RE: Coastal Development Permit Application for New Construction
Project No: PLN2021-00478
Project Address: 779 San Carlos Ave. El Granada CA
APN: 047-105-020

Project Description: A three bedroom, three bath residence with attached one bedroom, 1 bath Accessory Dwelling Unit (ADU).

Below are my responses to the minutes for the 8-11-2022 CRDC meeting regarding this CDP. The responses are in the order listed in the meeting minutes for clarity. All drawing revisions are identified with balloon notations and inverted delta notation, REV #, near the revision balloon. I have incorporated the revisions into the affected pages of the drawing set for your review. The Civil Engineering drawings are not yet revised to indicate the new configuration pending the wetlands/riparian dispute resolution and approval by the CRDC of the requested variance. The impact to these drawing by the revisions will result in a reduced impact to the site due to the reduced scope of the structure.

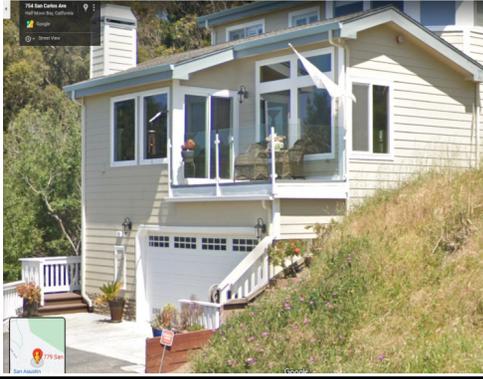
This application is for a 13' dimensional variance for a front setback, due to practical difficulty and special circumstances, including (but not limited to) size, shape, topography, location, or surroundings due to the properties unusual and special circumstances. The requested variance of a 13 foot proposed front setback for the non-garage structure, allows for habitable space adjacent to the garage on the first story of the building to accommodate the entrance and stairwell. The 30 foot riparian buffer zone and 20 foot front setback on the property prevents the construction of a normal size and shaped home. This plight, due to unique circumstances of the property, is not shared by neighboring properties in the same zone. Please reference Figure 1, Figure 2, and Figure 4 attached.

Figure 1 indicates the results of the topographical and biological survey of the property in question. LCP 7.11 (a) establishes an outward buffer zone limit of 30 feet for intermittent streams in riparian corridors. LCP 7.12 Permitted Uses in Buffer Zones, allows for "Residential uses on existing legal building sites, set back 20 feet from the limit of riparian vegetation, only if no feasible alternative exists, and only if no other building site on the parcel exists". Allowing a reduced front setback is an existing alternative and avoids the need to reduce the 30 foot riparian buffer zone to a lesser amount for the upper right section of the property. Strict compliance to the setback standard, in addition to enforcing the 30 foot buffer zone, is unnecessarily burdensome and granting the variance would do substantial justice to the owner. The strict application of the requirements and regulations prescribed in the zoning standard will unreasonably and substantially deprive the property of privileges enjoyed by other properties in the vicinity, and in the same zoning district, as the subject property.

1 SITE PLAN Ground Level
scale 1/8" = 1'-0"

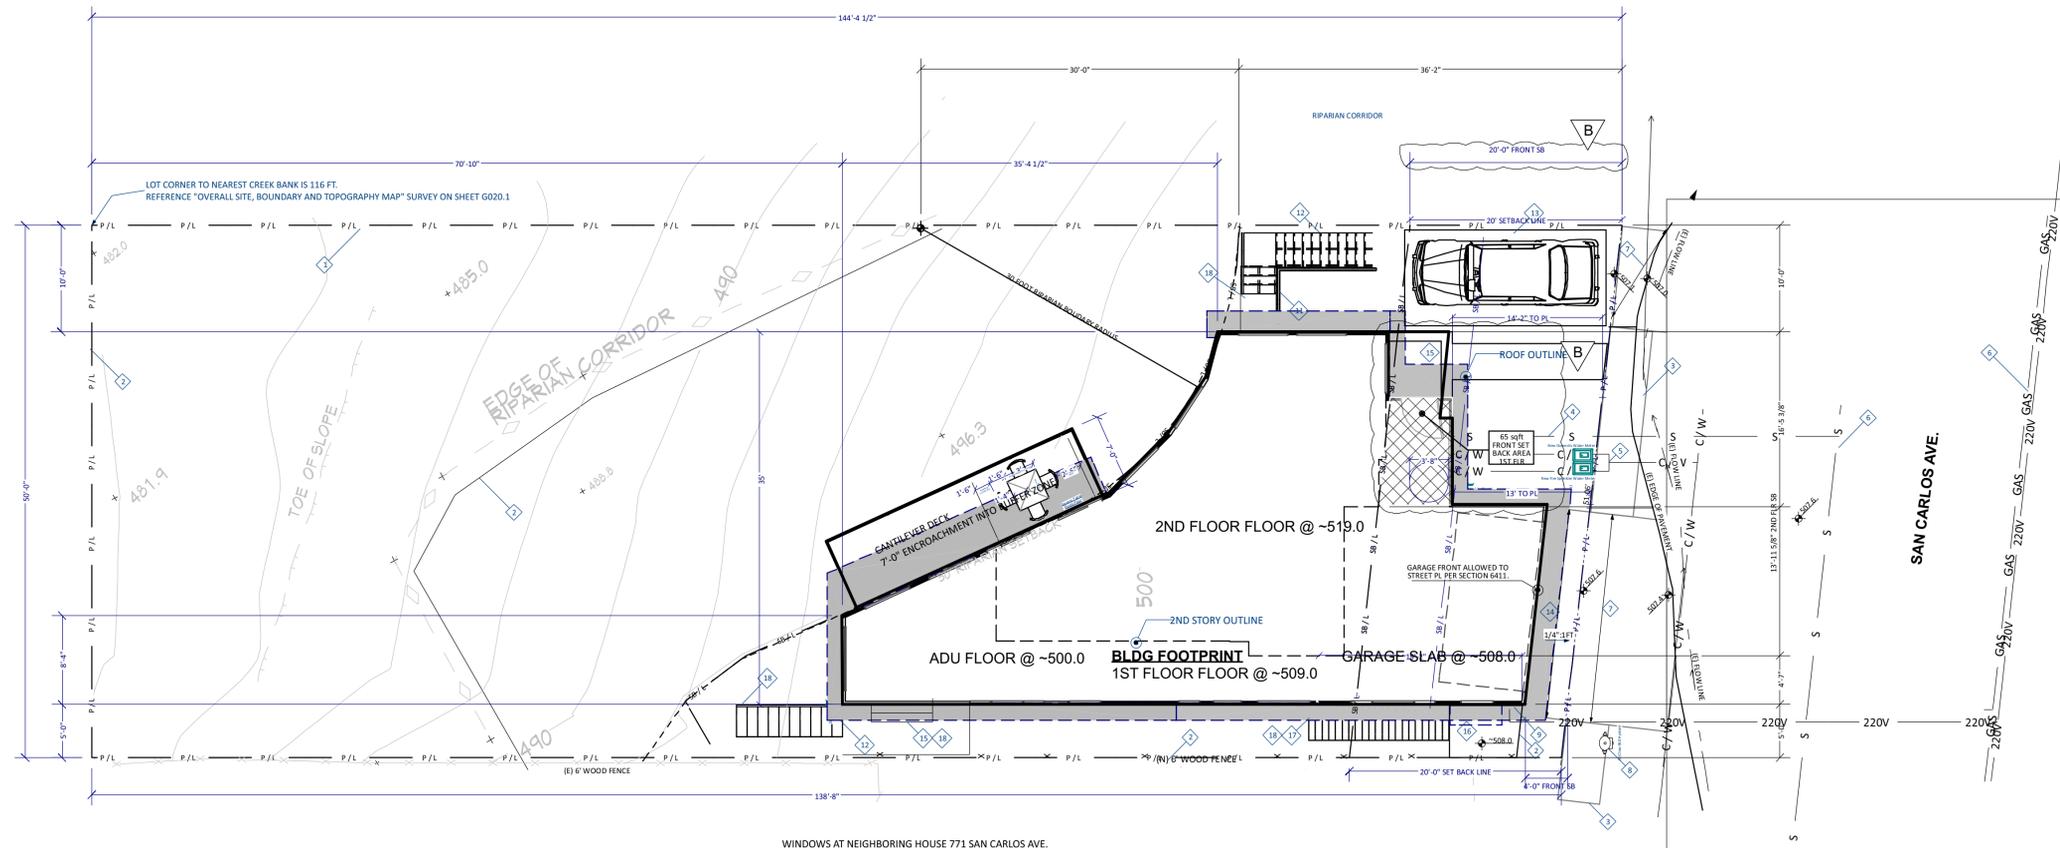
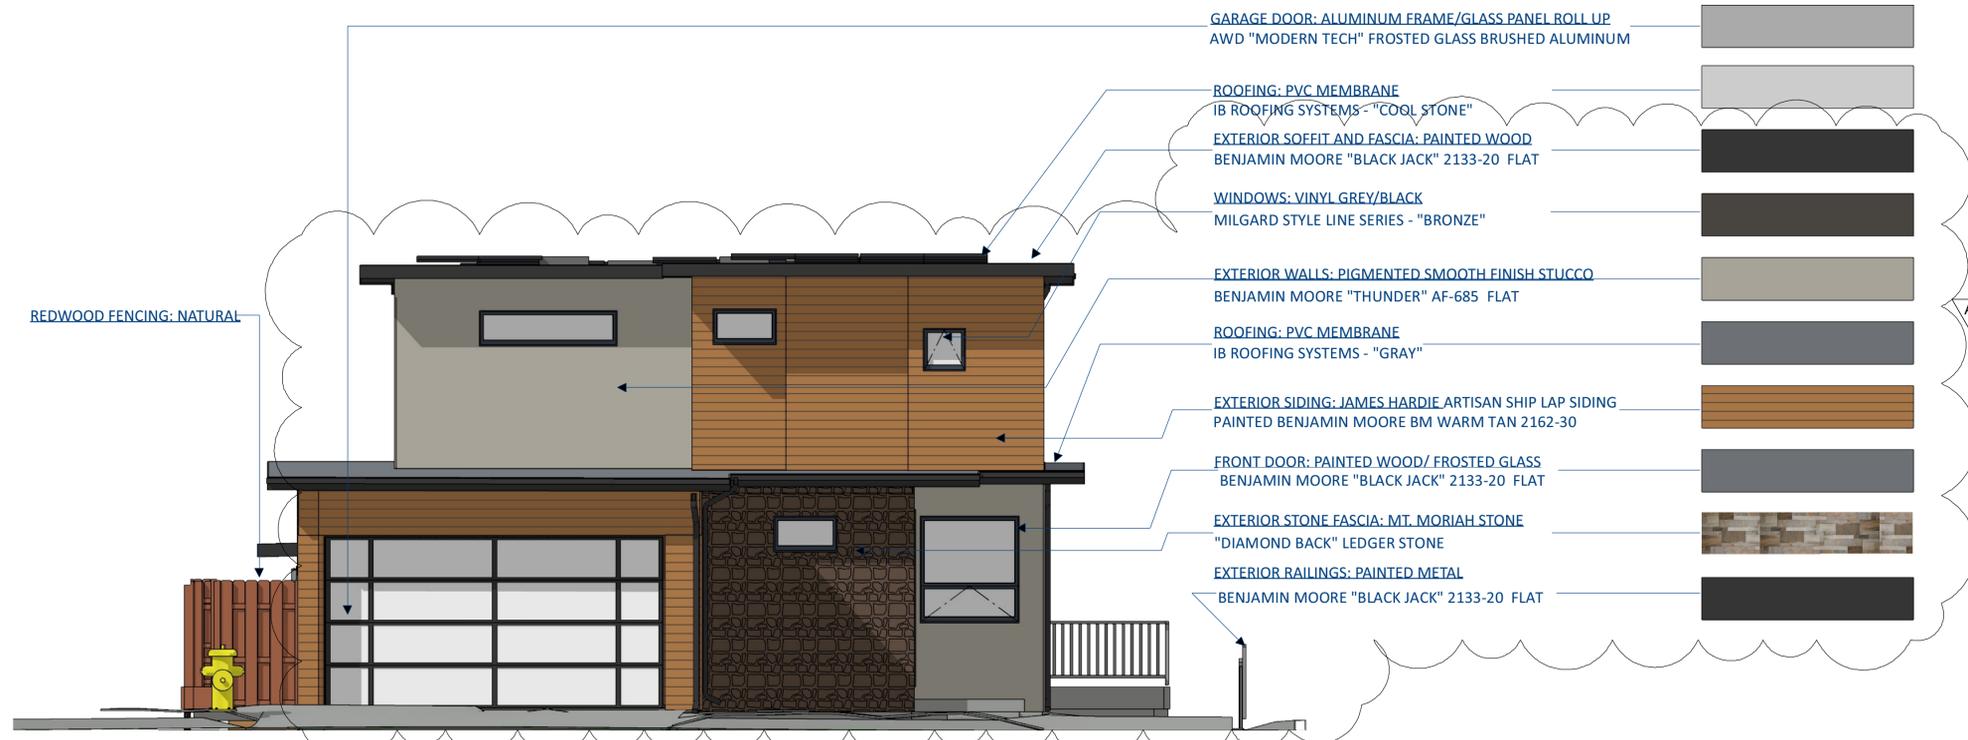
--CDRC does not support the extent of variance requested at the front of the home given the impact to the neighborhood scale and views. Reduce apparent mass and scale by limiting the requested variance to the first floor. Consider a split-level design to better accommodate the natural slope along with the neighborhood scale.

- The RDRC members indicated that a variance more in line with a 14'-16' distance would be more appropriate for approval (reference mtg recording time at 4:30).
- The design has been revised to remove the bedroom and bath over the garage. The rear second story deck has been relocated and reduced in size. The second floor bedroom and bath on the right side of the property (bedroom 2) have been brought back from their original location from the front property line by 14'-5". The second story is now within the 20' sect back line. The first floor entrance and stairwell wall have been brought back 11'-0" from the original location as well. The front setback is now 13'-0" (a variance request of 7').

2 FRONT ELEVATION (NE)
scale 1/4" = 1'-0"

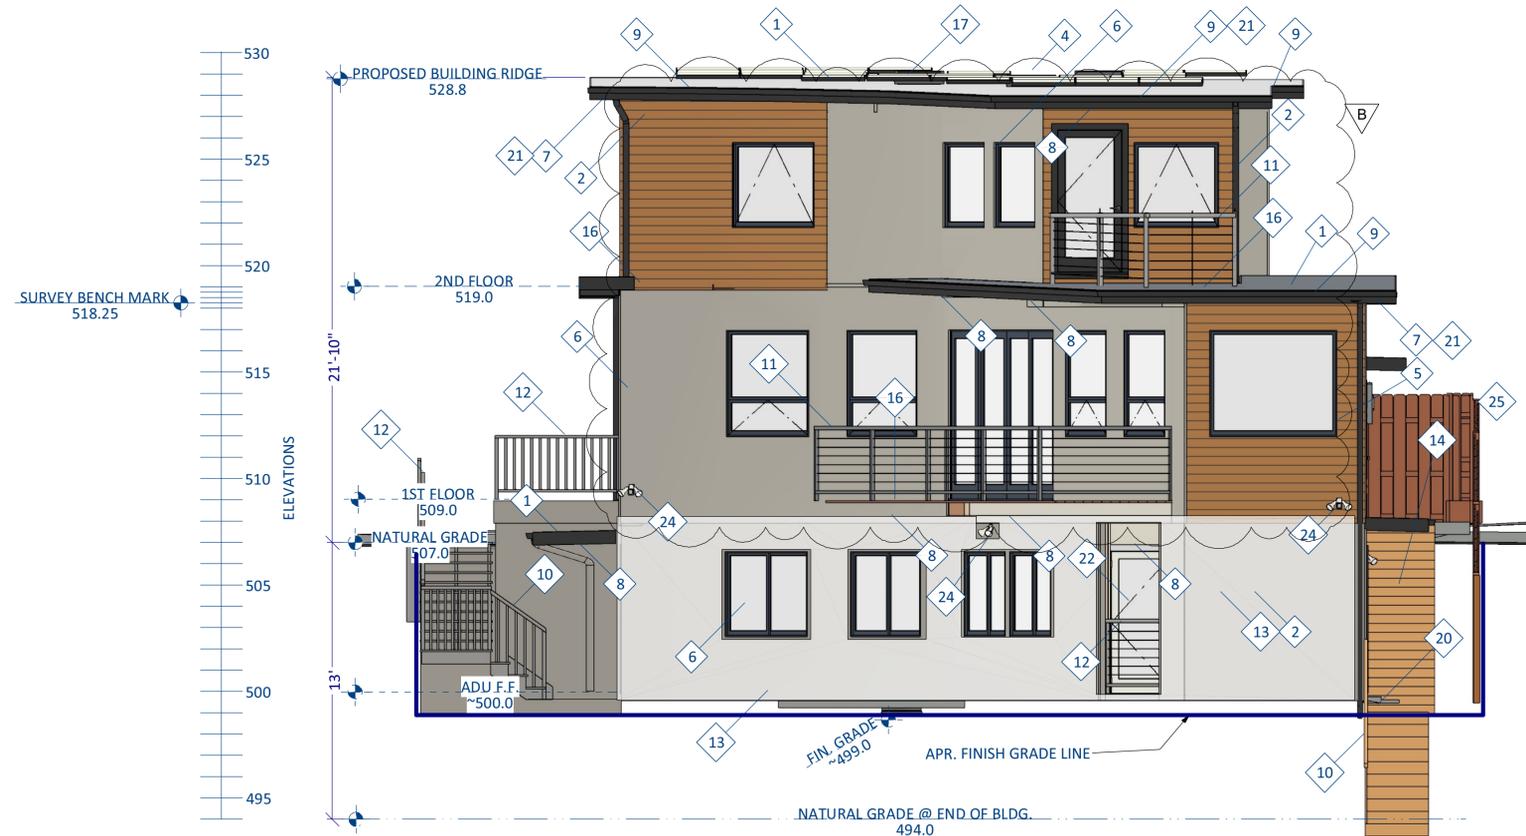
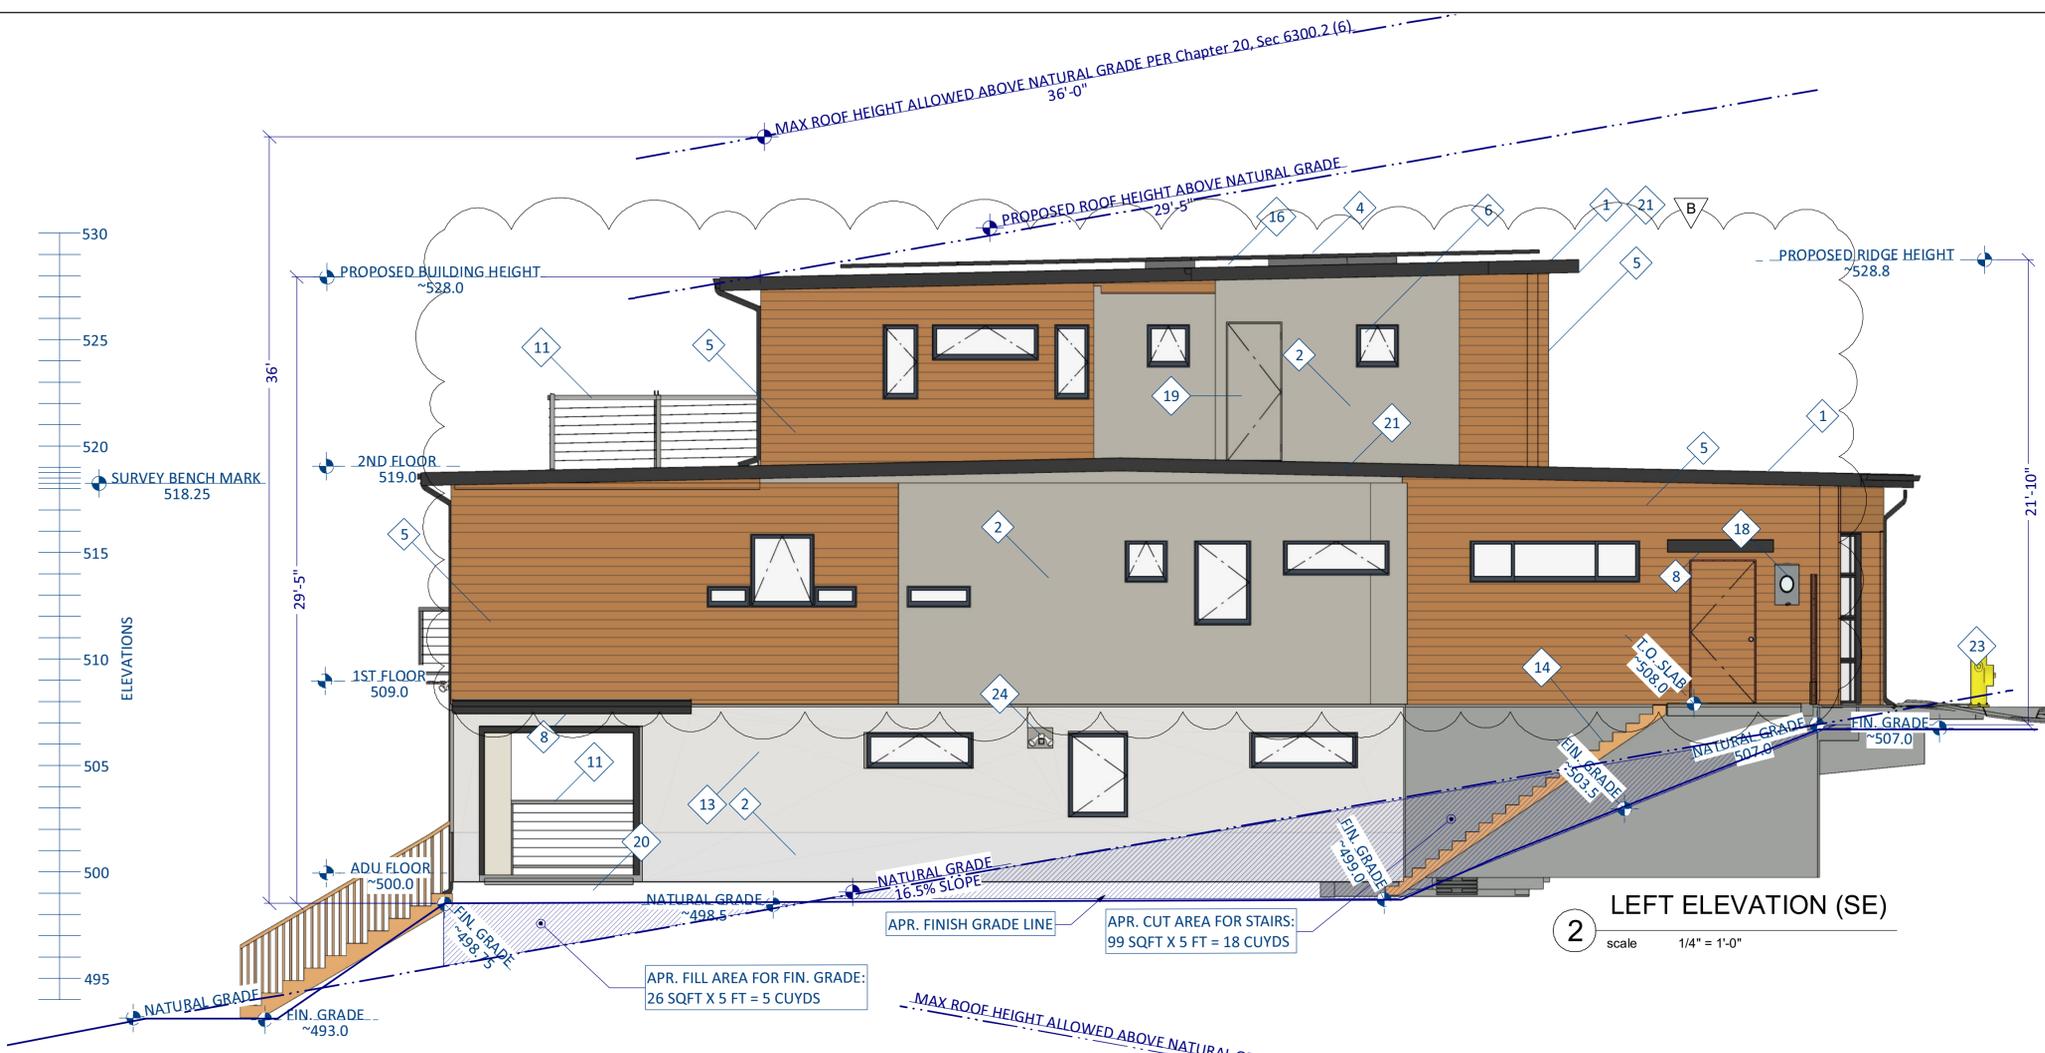
--CDRC has concerns about exceeding the standard maximum height of 28' given the impact to the neighborhood scale and views. Reduce apparent mass and scale by lowering the plate height and/or lowering the eave line.

--Front elevation materials/colors appear disjointed from the rest of the design. Apply the materials/color placement more thoughtfully and consistently on all elevations for a cohesive composition.

- The house design never exceeds the 28' maximum height limit.
- The apparent mass and scale have been reduced by removing the bedroom and bath over the garage and by moving the second story away from the front PL as much as is allowed to the rear 30 foot riparian setback limit. This results in a reduction of the front PL plate heights for the as follows:
 - From eave line elevation 529.1 to 528.1 for the 2nd story master bath front wall.
 - From eave line elevation 529.1 to 528.8 for the 2nd story bedroom bath wall.
- The ACTUAL physical mass and scale have been reduced by eliminating the bedroom and bath over the garage and by moving bedroom number 2 towards the rear of the property by placing it at the 20' set back limit.

- SECTION 6565.20(D) ELEMENTS OF DESIGN; 4. Exterior Materials and Colors
 - All elevations have been revised to incorporate additional articulation and to deploy a more cohesive distribution of stucco/siding to reflect an improved methodology and grounding approach.
